Intel® High Definition Audio Specification

Document Change Notification

Change Identification: **DCN No: HDA015-B**
Document Revision: Intel® High Definition Audio 1.0

Title: Low Power Capabilities Clarifications and Enhancements

Figure F1. Power State Field Definition

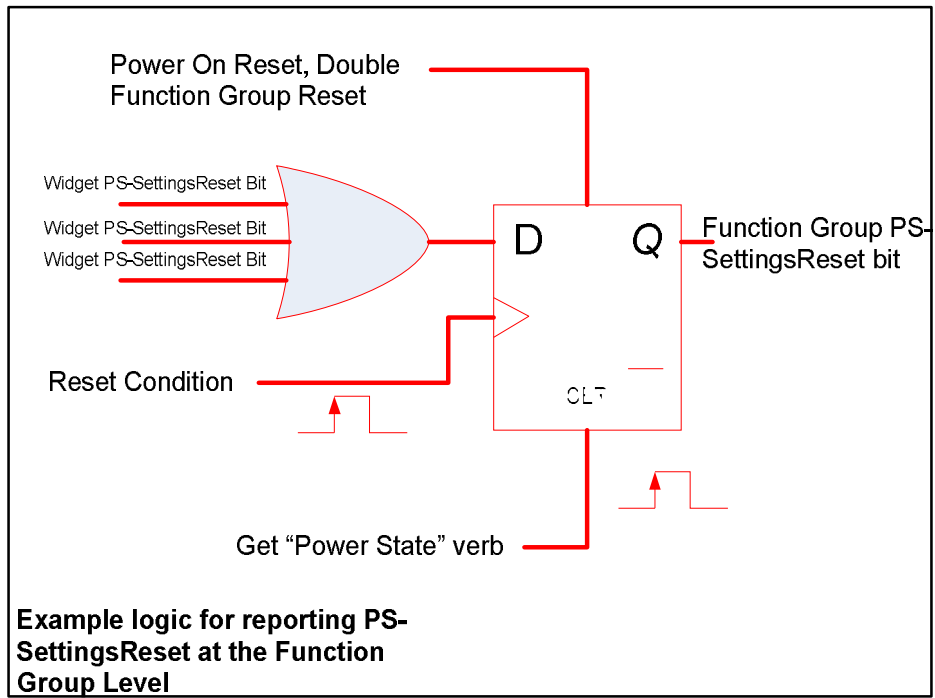
The PS-SettingsReset bit is 'sticky'. Once set, it will retain its value until it's cleared by a 'Get' verb, regardless of other single or double Function Group resets, Dx state transitions etc that may occur in the meantime.

7.4.2 Audio Jack Detection Circuits

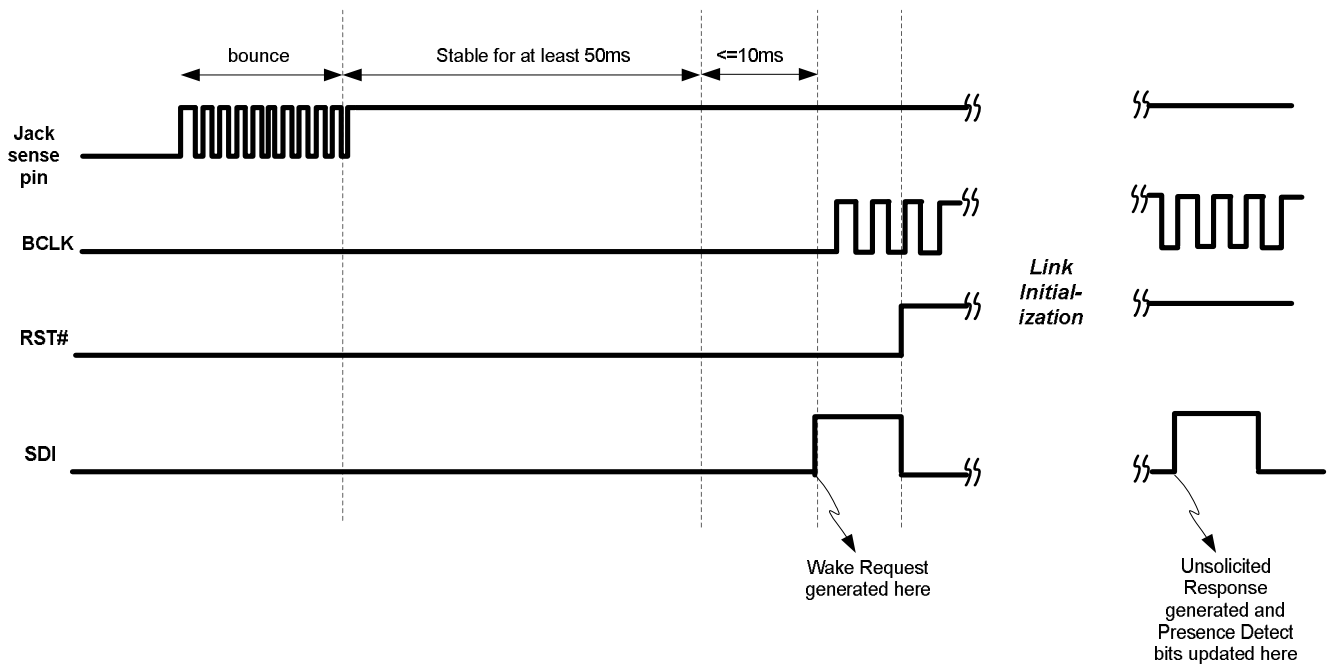
When detecting the insertion or removal of a jack, where the impedance of a shared sense line is being used, the codec shall measure the impedance of the jack's presence detect precision resistors continuously to determine when to report a change of state. Reporting of state change and change in the presence detect state bits shall not occur until any impedance (does not preclude other measurement techniques) change has initially stabilized for at least 50 Milliseconds. From the point at which the impedance has stabilized the codec shall report an Unsolicited Response, if enabled and the High Definition Audio Link clock is running, within 10 Milliseconds. If this clock is not running, then the request to wake the Link shall occur within 10 Milliseconds. Thus any presence detection logic used to detect which resistors are switched in for the purposes of Presence Detection, must operate more quickly than 10 Milliseconds. Once the unplug or plug event has been signaled to the host through the unsolicited response, another event or change of the presence detection bits shall not be generated unless the opposite jack state has been sensed (detected) continuously for at least 50 Milliseconds. The state of the Presence Detect bits for all the jacks associated with a shared sense line shall not change until the point where an Unsolicited Response could be generated, if disabled,

or is generated when enabled. Thus the state of the Presence Detection bits should be “de-bounced” with hysteresis of at least 50 Milliseconds, but longer times are permissible as long as the initial state change and reporting time is met. When the codec has returned to D0 from any lower power state, the state of the presence detection bits must be correct. If the codec power has been removed and the state of the presence detection bits has been reset, the codec shall report this by setting the PS-SettingsReset bit for the affected Pin Widget(s). The timing specifications described above are demonstrated in the following diagrams:
